PERMIT

SEWAGE DISPOSAL SYSTEM

HOWARD COUNTY HEALTH DEPARTMENT

SUBDIVISION Harris Property LOT 3 ROAD 16196 Frederick Road

A50548-B

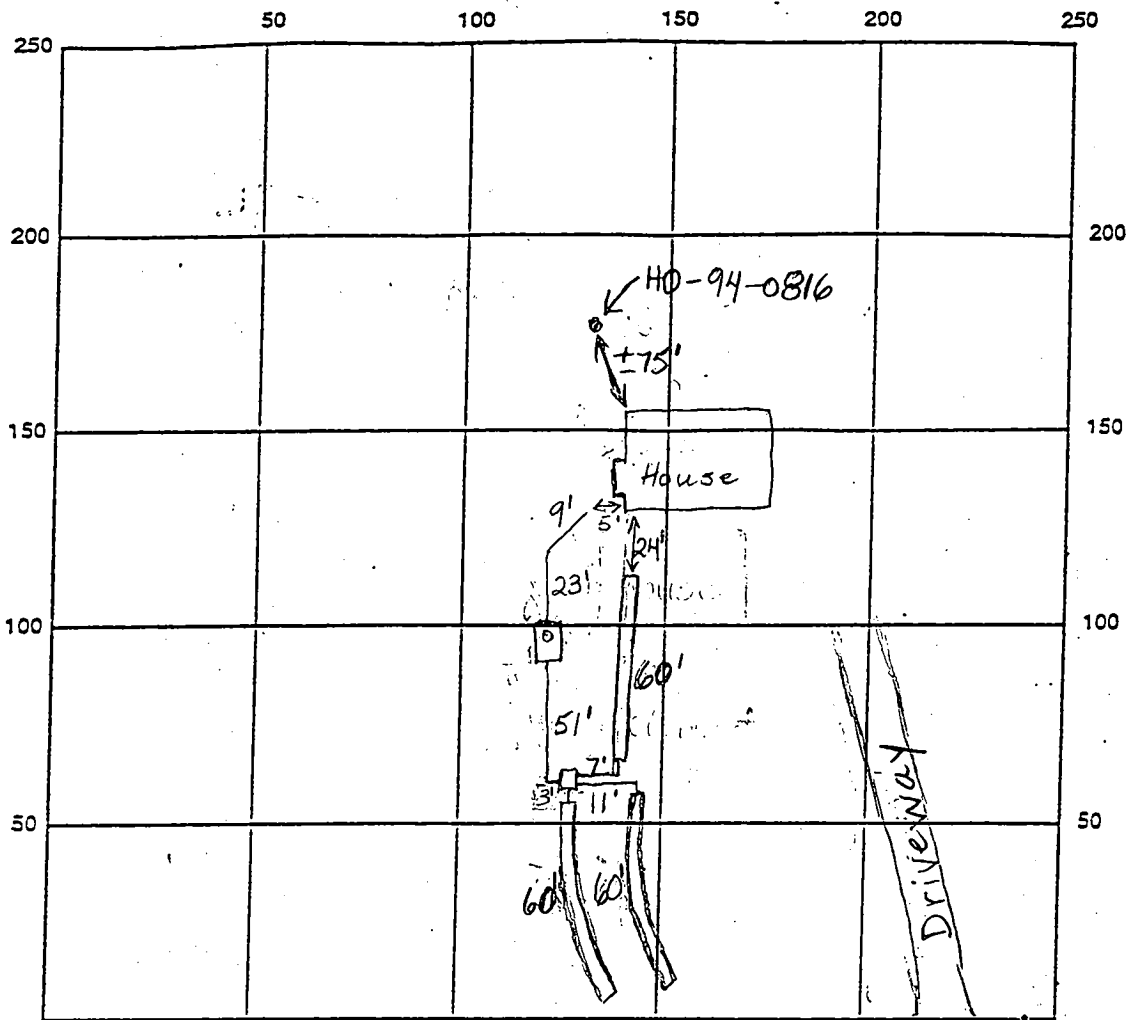
REMARKS: No House Connection. Installer wants to dig deeper trenches in order to avoid using septic pump. Told him to call Ron. 7/15/99 (BB) 7/16/99 O.K. to cover system. Final approval pending 5' section that needs to be connected to house. System design changed so that pump not needed. Two trenches from house almost a foot deeper than specs. (BB) 10/27/99 HOUSE CONN CERTIFIED BY OWNER HR/

I spoke to Kurt @ Fogle's -
he explained that a pumped
septic system may not be
necessary if they were
able to install the high
trench 8"-12" deep than
specified. Due to my know-
ledge of soil conditions @
site, I approved change
in trench depth.

FOUNDATION LOCATED HARRIS PROJECT LOT

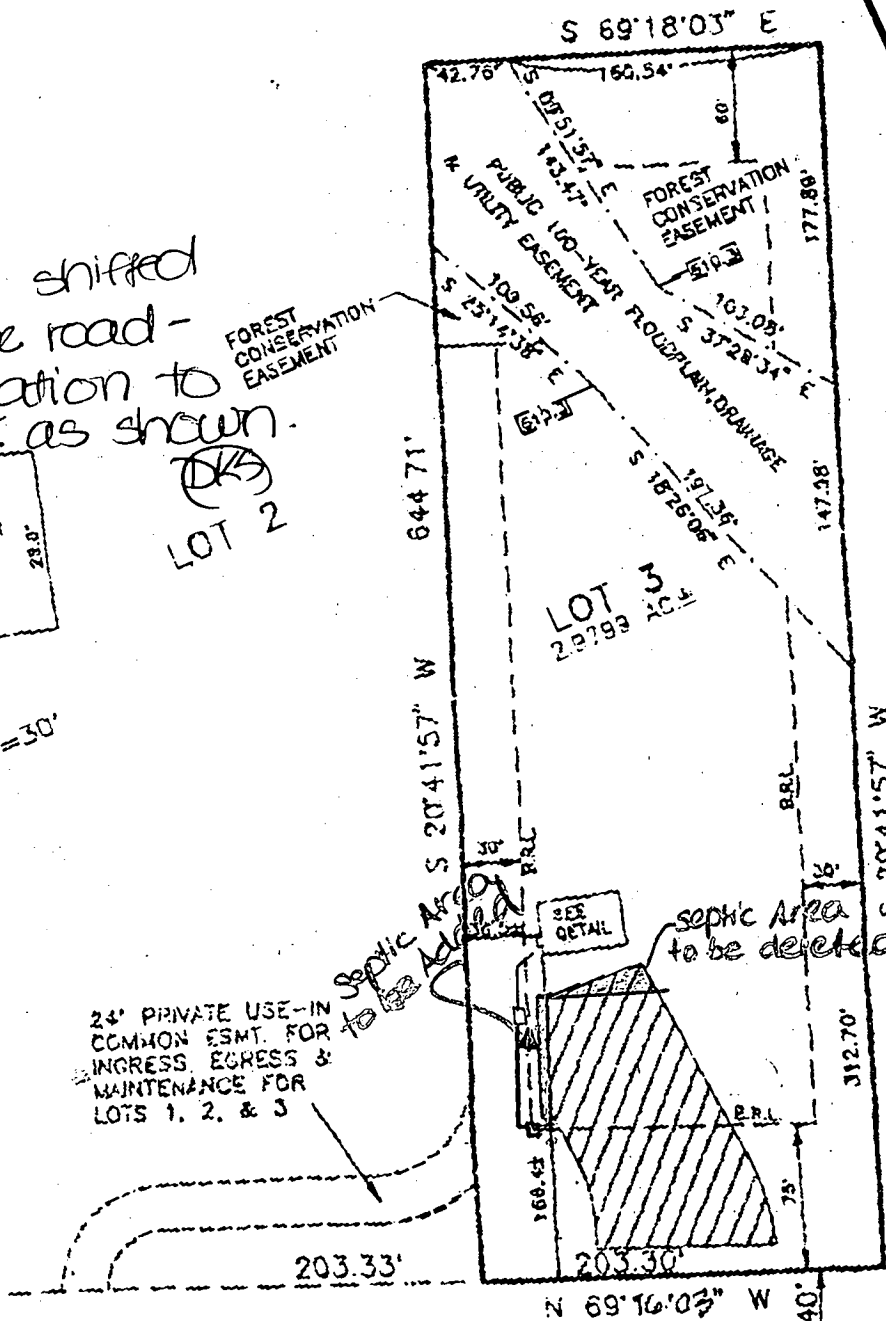
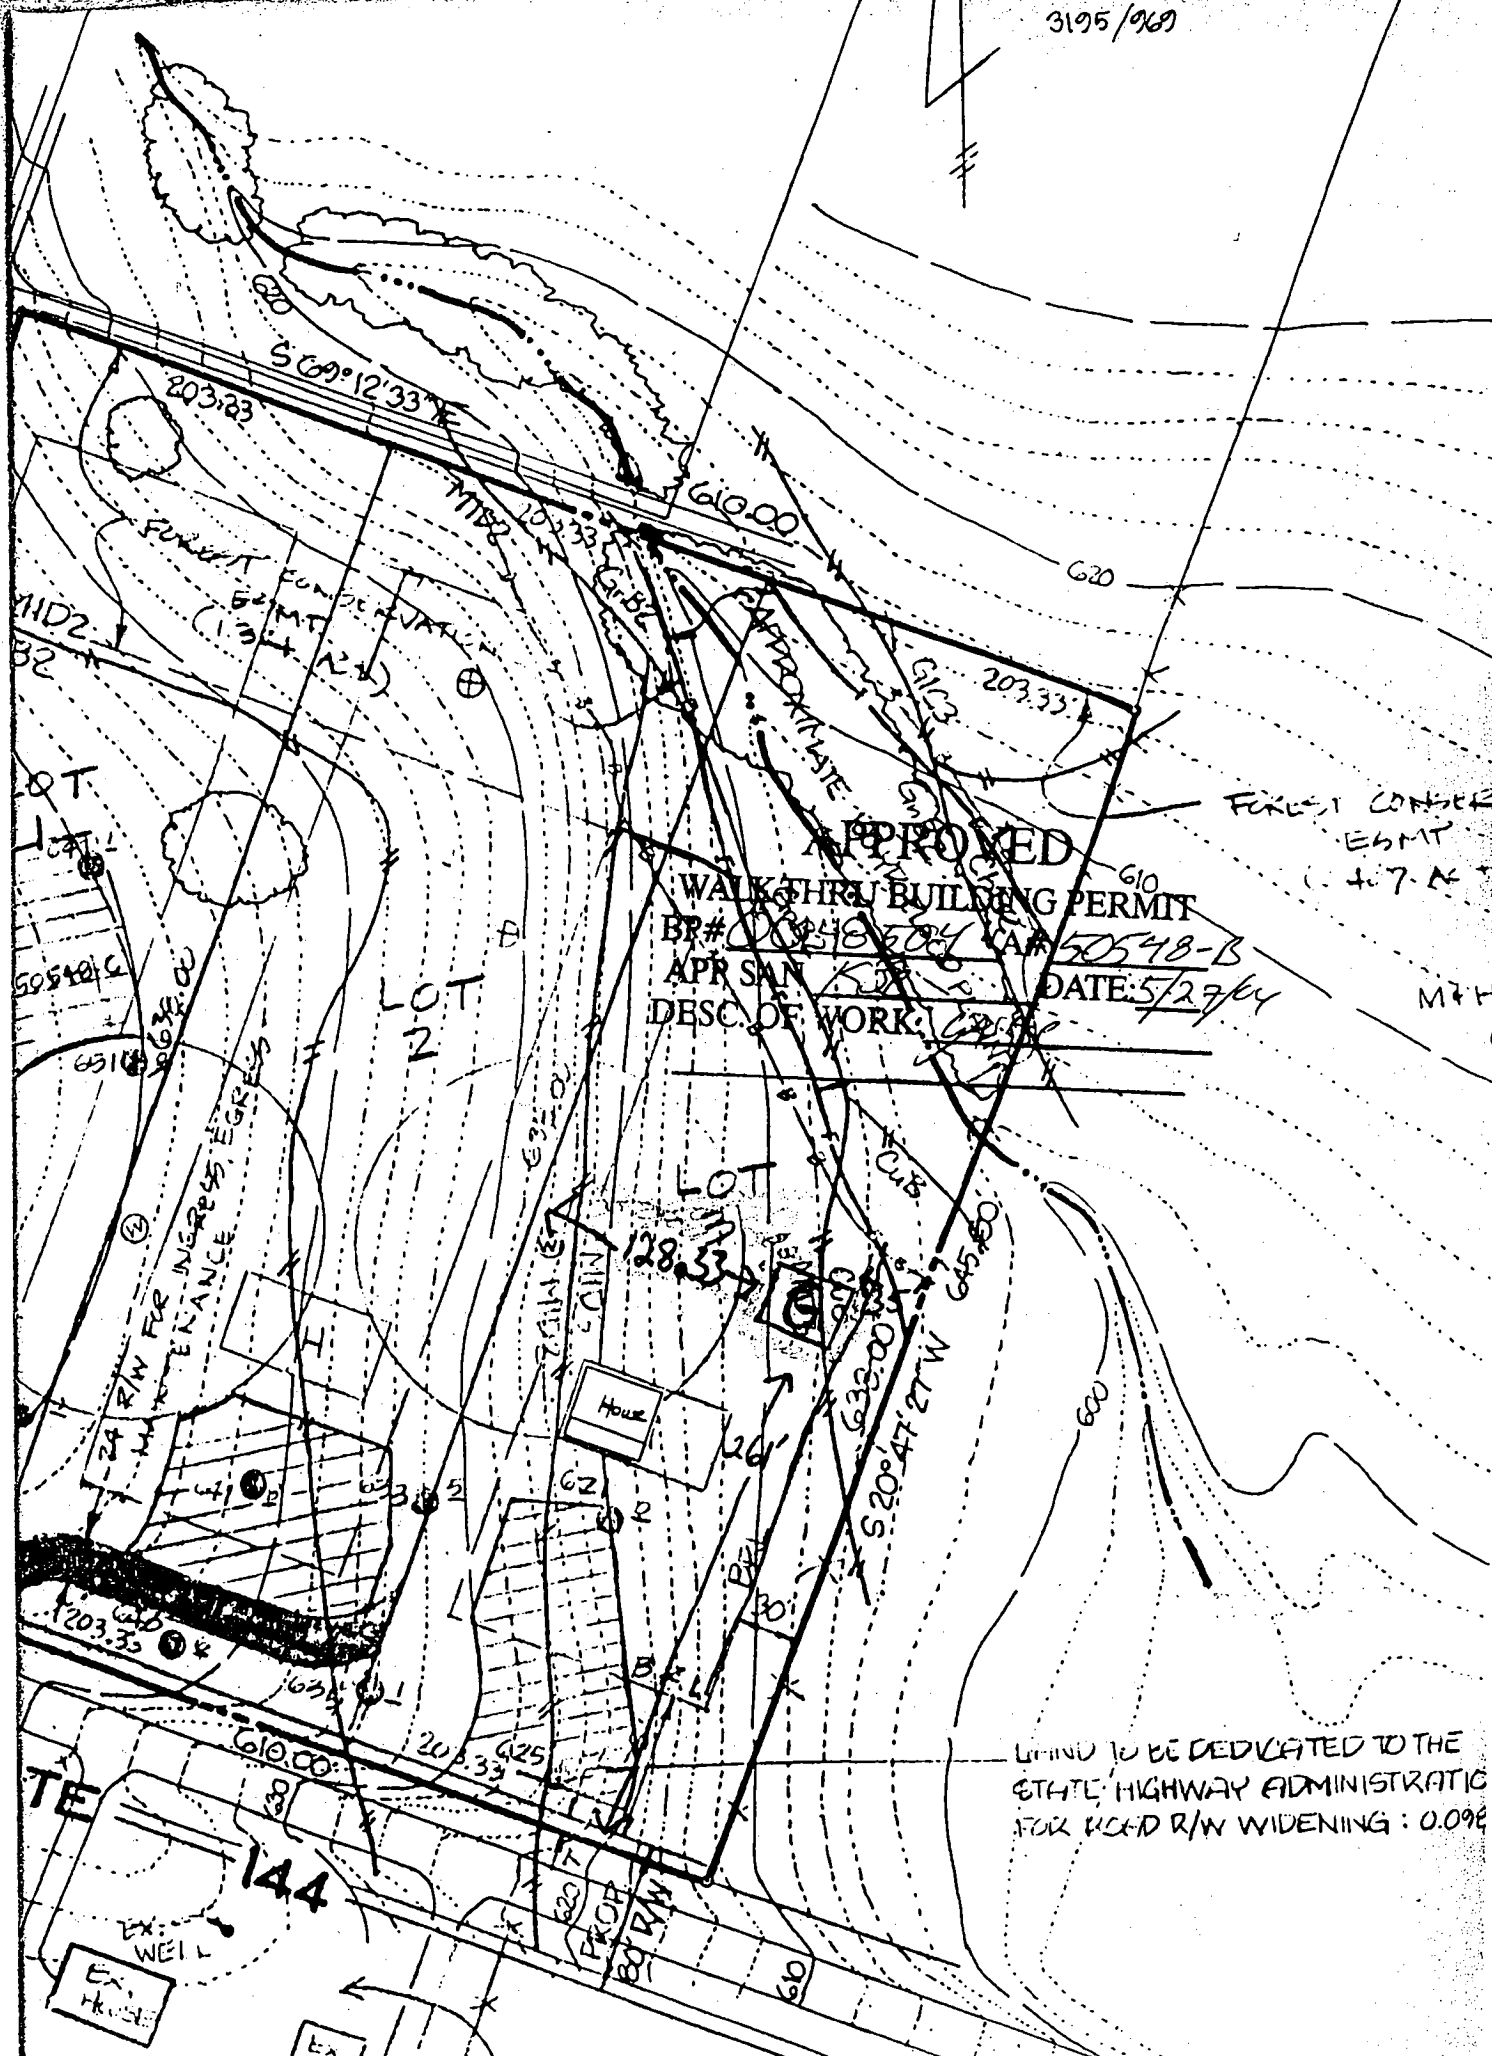
House has been shifted 22'± towards the road - slight modification to septic area OK as shown.
